SUBMITTAL OF 241-C-110 TANK WASTE RETRIEVAL WORK PLAN (TWRWP), REVISION 2, RPP-33116 AND ASSOCIATED REVIEW COMMENT RECORD (RCR) RESPONSES

241-C-110 TANK WASTE RETRIEVAL WORK PLAN, REVISION 2, RPP-33116

241-C-110 Tank Waste Retrieval Work Plan

Attachment #3 to RPP-33116 Rev 1 RCR for Comment #15

Figure 2-3. Tank C-110 Surface Level History from 1946 to 1995.

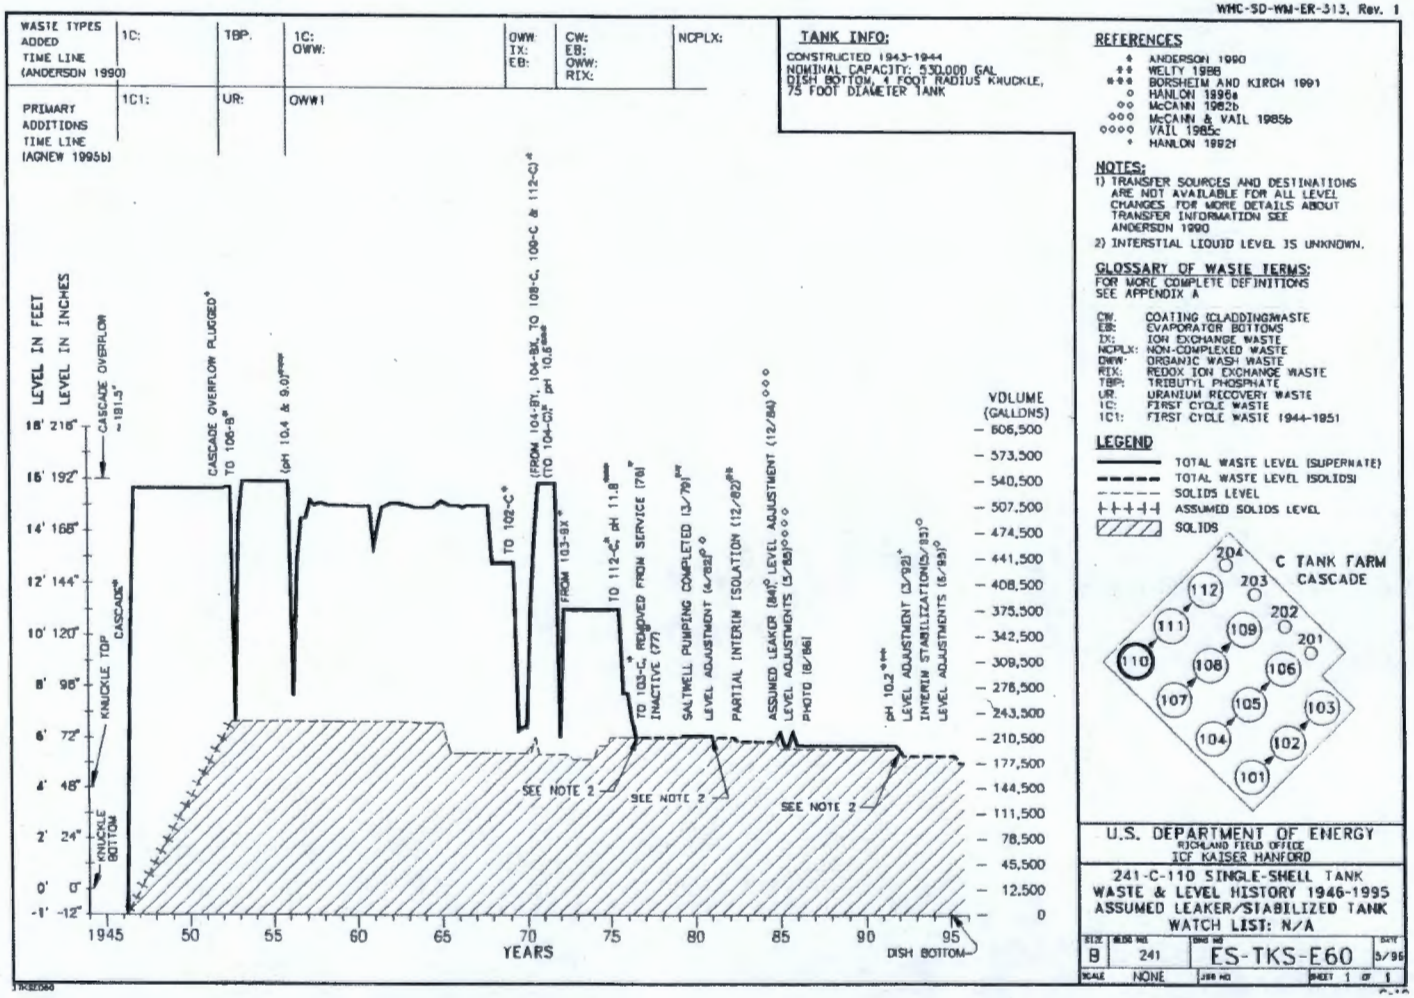
Item	Page #	Comment	Hold Point	Disposition (Provide justification if NOT accepted)	Status
				was in 1991. Second, Figure 2-3 shows the surface and sludge level history. The vast majority of sludge was added between 1946 and 1952 when 1-C waste, the first cycle waste from bismuth phosphate processing, was added to the tank. Several hundred thousand gal of OWW waste was added to the tank in 1956, but sludge level data show no solids increase. The OWW liquid was subsequently pumped out of the tank. The OWW stream from Purex was a low level stream, containing less than 1% of the fission products in the dissolved fuel. It was a combination of two waste streams, both dilute Na_2CO_3-$KMnO_4$ mixtures used to wash the two plant organic systems, one of which was contained in a cell routinely entered by personnel. Thus, the heat generating potential of this stream was low. The heat load in C-110 has been low in this tank compared to tanks that received more concentrated first cycle wastes. In response to a verbal request from Ecology, wording has been added to Section 2.1.4 describing some of the thermal history of C-110.

Figure 4-3. Leak Detection Methodology for SST Retrieval.[1]

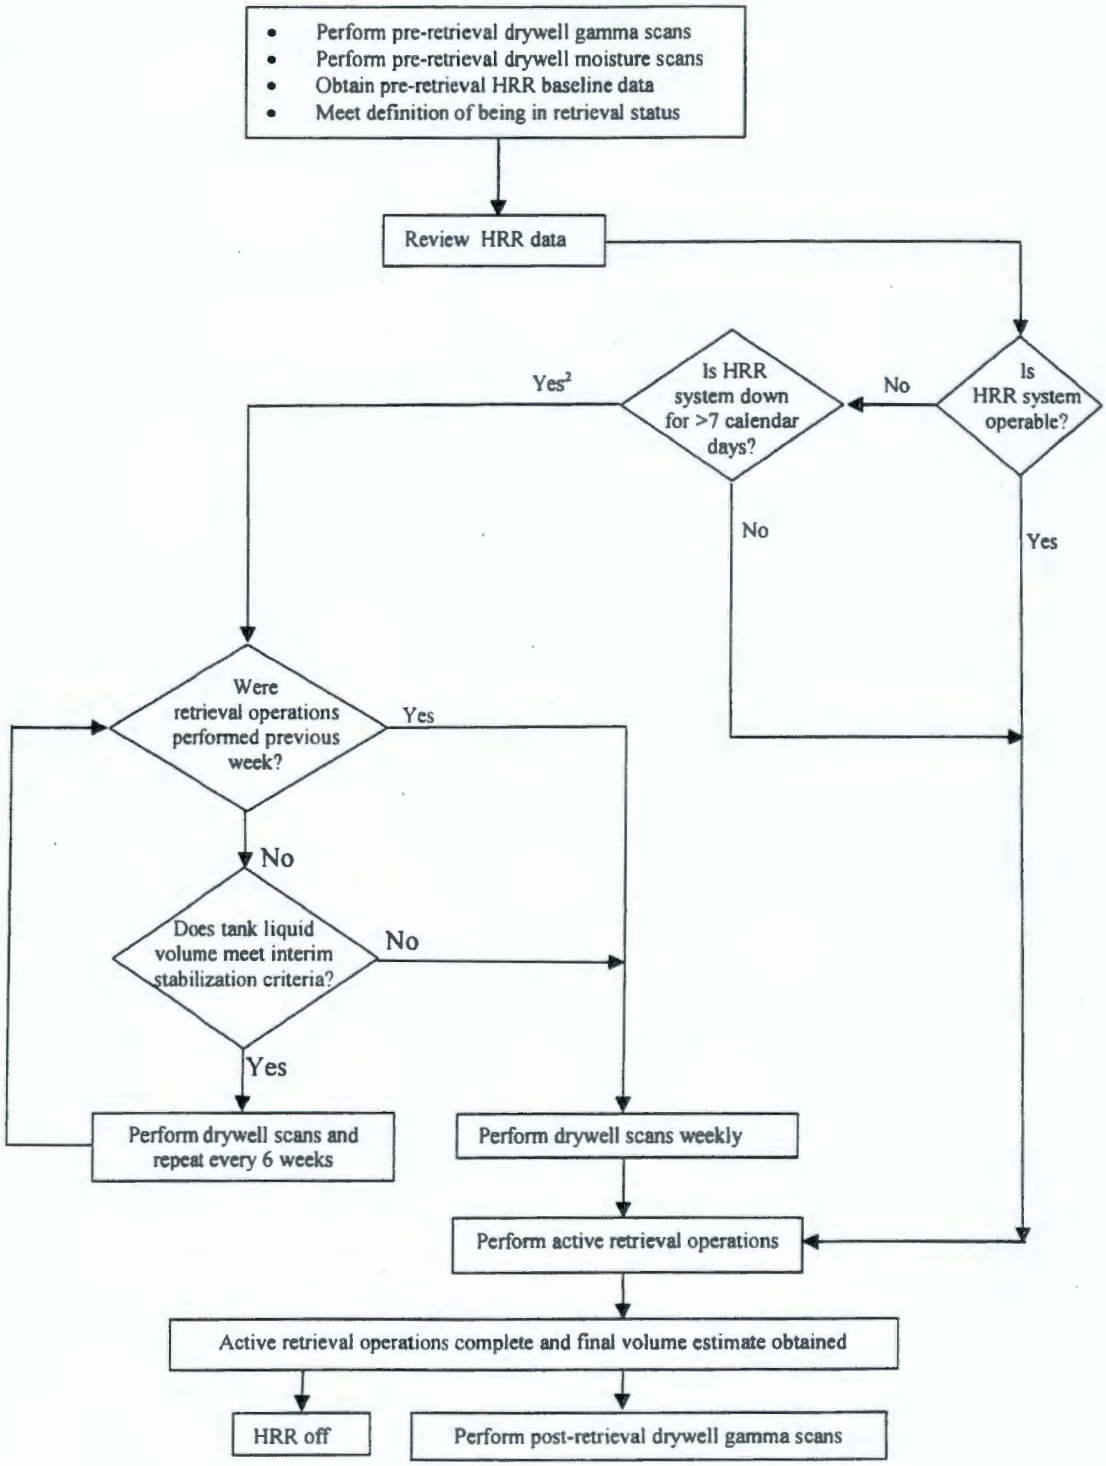
Item	Page #	Comment	Hold Point	Disposition (Provide justification if NOT accepted)	Status
		4) Dry Well monitoring with moisture measurements will be conducted as a backup means of leak detection if the HRR system becomes inoperable.		section 4.2.1.1, and drywell monitoring will be used as a backup if HRR becomes inoperable as stated in section 4.2.1.1, section 4.2.1.3, and in Fig 4-3.
